Project No. 18109907

**PERMIT MODIFICATION – ATTACHMENT 14
REMEDATION PLAN FOR LANDFILL GAS EXCEEDANCES
POLK COUNTY WASTE MANAGEMENT FACILITY (PERMIT NO. 1384A)
RN102668654/CN600336077**

PROJECT				
LANDFILL GAS COLLECTION AND CONTROL SYSTEM DESIGN				
POLK COUNTY LANDFILL, TCEQ PERMIT NO. MSW-1384A				
POLK COUNTY, TEXAS				
TITLE				
GAS COLLECTION AND CONTROL SYSTEM				
PROJECT NO.	PHASE	REV.	1 of 2	FIGURE
18109907	0001	0		C-1

PROJECT NO. 18109907	PHASE 0001	REV. 0	2 of 2	FIGURE C-2
-------------------------	---------------	-----------	--------	---------------

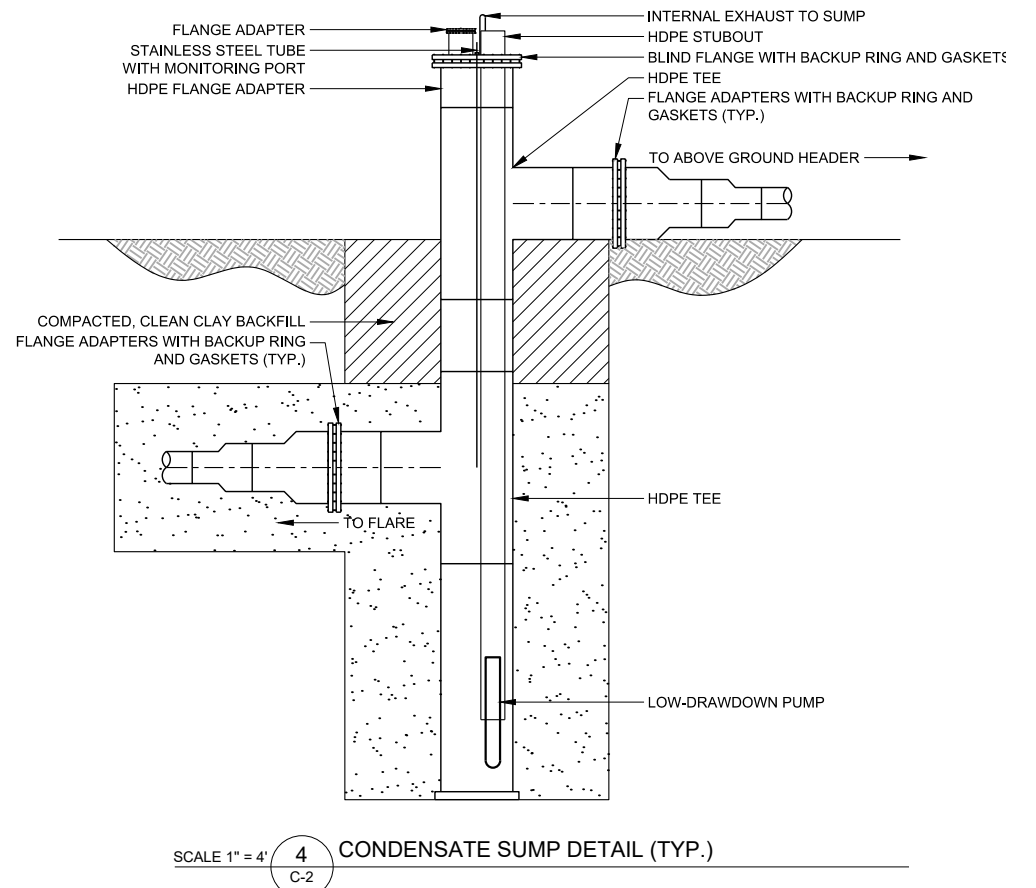
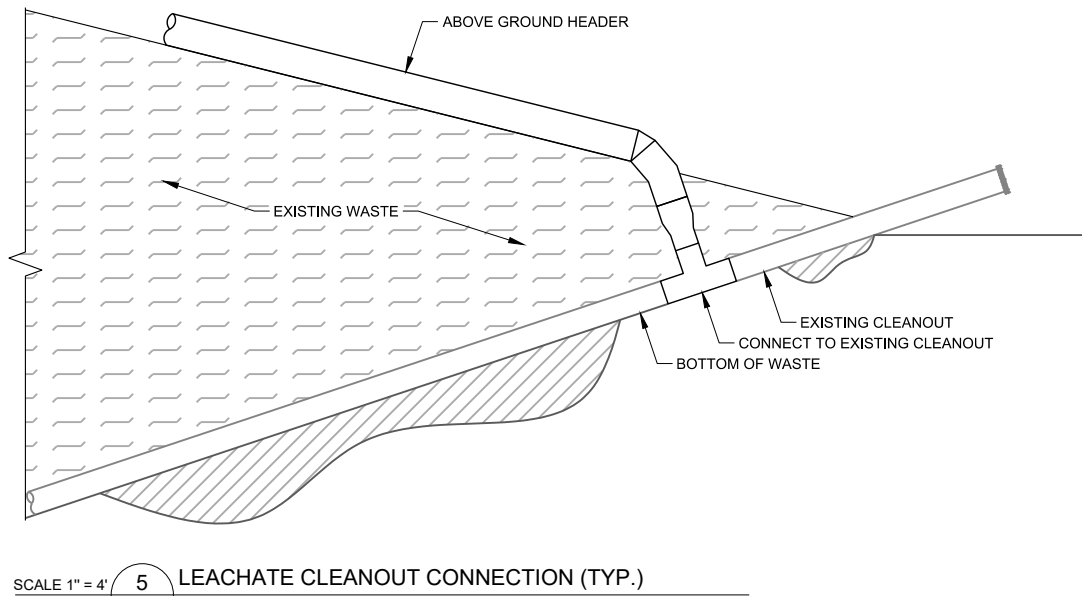
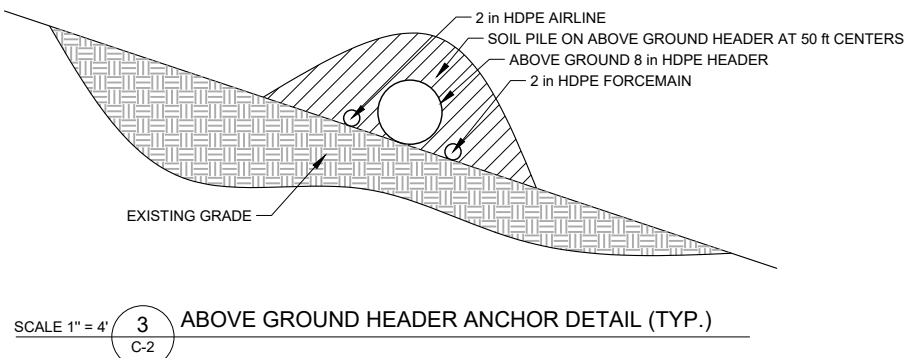
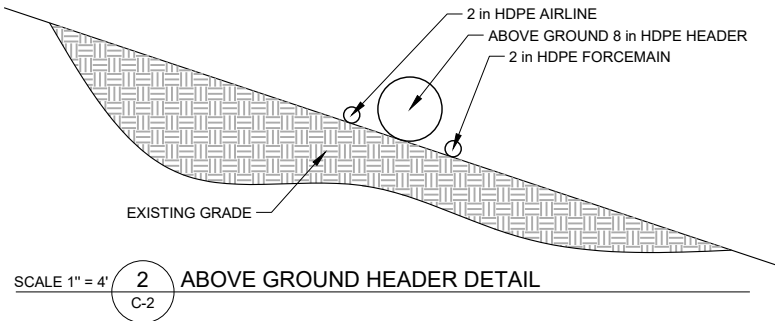
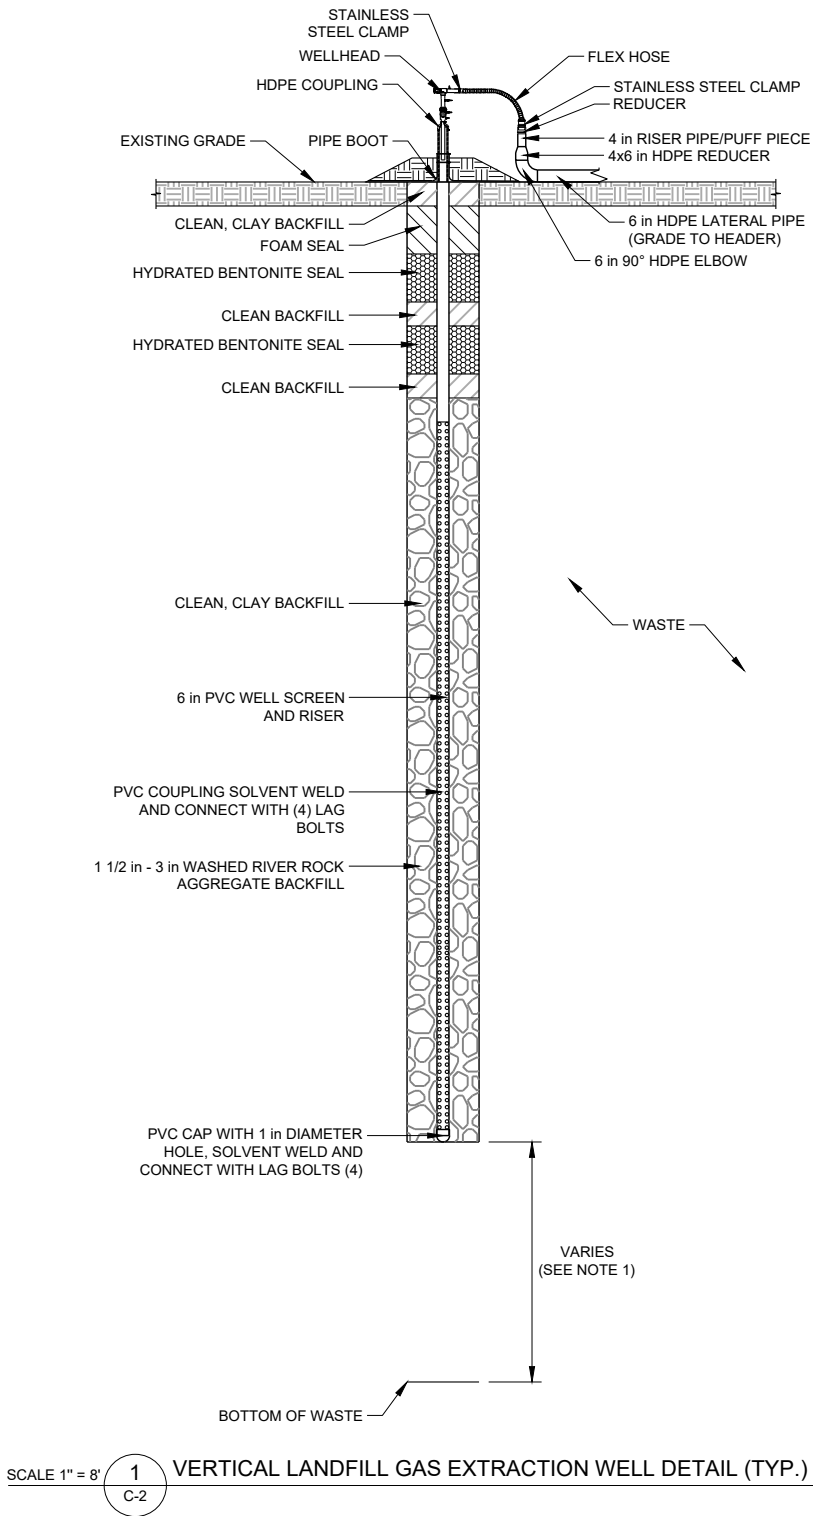
To remediate the gas exceedances, Santek proposes additional gas collection and control system (GCCS) components within the landfill footprint consisting of vertical gas extraction wells with associated laterals, headers with associated airlines and force mains, and condensate sumps.

The proposed GCCS layout and details have been added as Appendix C to Attachment 14 – Leachate Gas Management Plan (LGMP).

- NOTE(S)**
1. BOTTOM OF WELL ELEVATIONS SHALL BE LOCATED A MINIMUM OF 10 ft ABOVE BOTTOM OF WASTE ELEVATIONS IN AREAS LINED WITH GEOSYNTHETIC LINER. BOTTOM OF WELL ELEVATIONS IN PRE-SUBTITLE D AREAS WILL BE KEPT WITHIN WASTE BASED ON THE PERMITTED CLAY LINER ELEVATIONS.
 2. UPON EXPANSION OF THE GAS COLLECTION SYSTEM, LIQUIDS MAY BE COLLECTED BY CONNECTING PIPING TO CELL LEACHATE CLEANOUT RISERS AS NECESSARY.
